SERVICE INFORMATION NO. SI D4-108

All DA 40 D aircraft equipped with GARMIN G1000 System.

GARMIN Service Alert No. 0824
ATA-Code: 34-00

SUBJECT: GDU 104X CRS/BARO Knob Interference

Figure 1

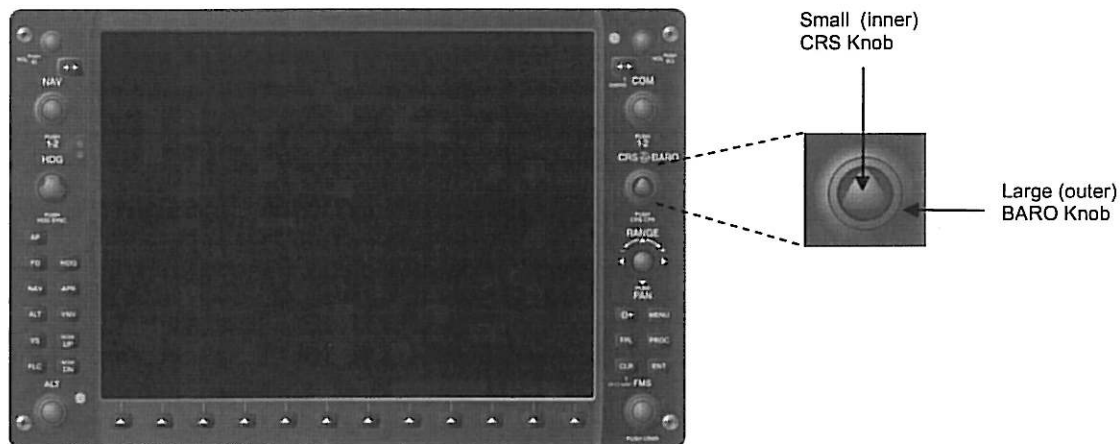
Garmin has identified an issue, whereby the large (outer) BARO knob and the small (inner) CRS knob may interfere with each other.

1. Apply power to the G1000/G900X/G950.
2. Press the CDI softkey on the Primary Flight Display(s) (PFD) to enter VOR mode on the HSI.
3. Rotate the large (outer) BARO knob (refer to Figure 1) a minimum of three complete revolutions in each direction while monitoring the Horizontal Situation Indicator/Digital Course Indicator (refer to Figure 2) on the PFD. If a change in the Horizontal Situation Indicator/Digital Course Indicator is produced while turning the BARO knob proceed to the Modification Instructions.

Figure 2

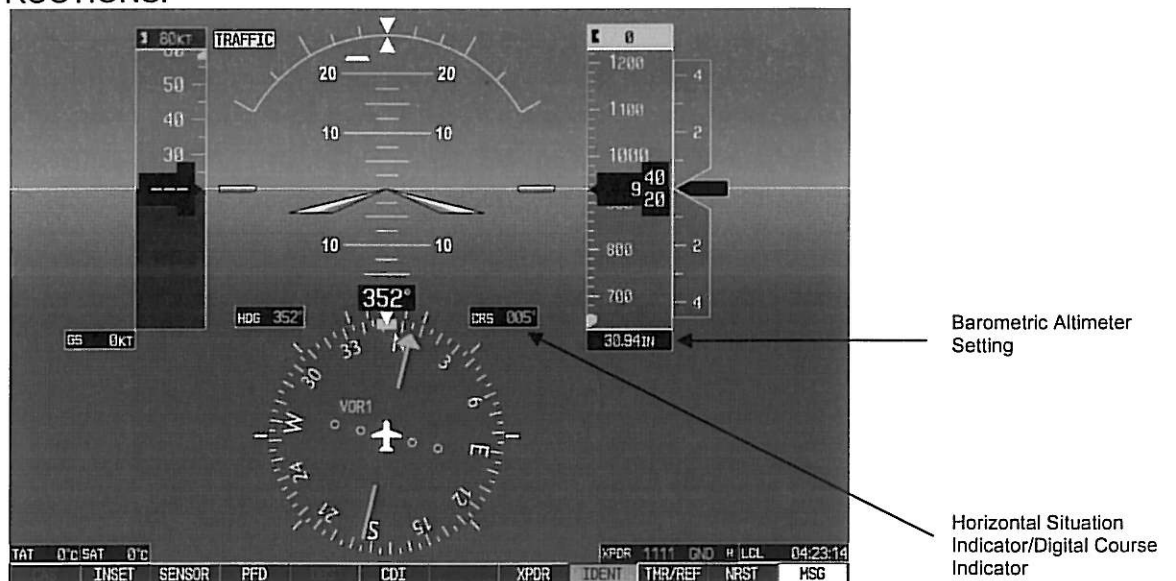
4. Rotate the small (inner) CRS knob (refer to Figure 1) a minimum of three complete revolutions in each direction while monitoring the Barometric Altimeter Setting (refer to Figure 2) on the PFD. If a change in the Barometric Altimeter Setting is produced while turning the CRS knob proceed to the Modification Instructions.
5. Repeat Steps 3 and 4 for each affected GDU.

Figure 3

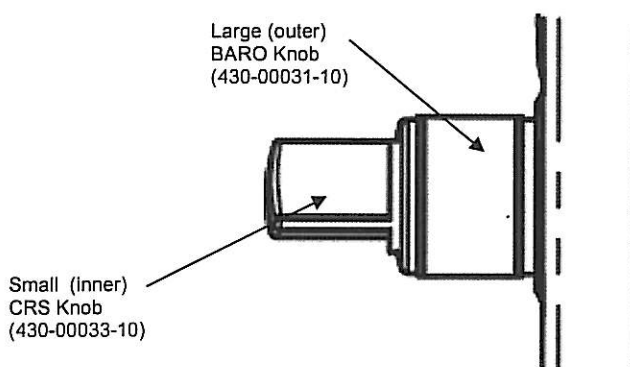
5. Grasp the large (outer) BARO knob (insuring proper orientation) and place it over the shaft.
6. Align the flat side of the knob insert with the flat side of the shaft.
7. Press down firmly to ensure knob is completely seated, refer to Figure 3.
8. Grasp the small (inner) CRS knob (insuring proper orientation) and place it over the shaft.
9. Align the flat side of the knob insert with the flat side of the shaft.
10. Press down firmly to ensure knob is completely seated, refer to Figure 3.
11. Perform the CRS/BARO Knob Interference Test (contained in the TESTING PROCEDURE section) again to confirm there is no interference.
12. Accomplish aircraft logbook entry to return aircraft to service in compliance with this service bulletin.
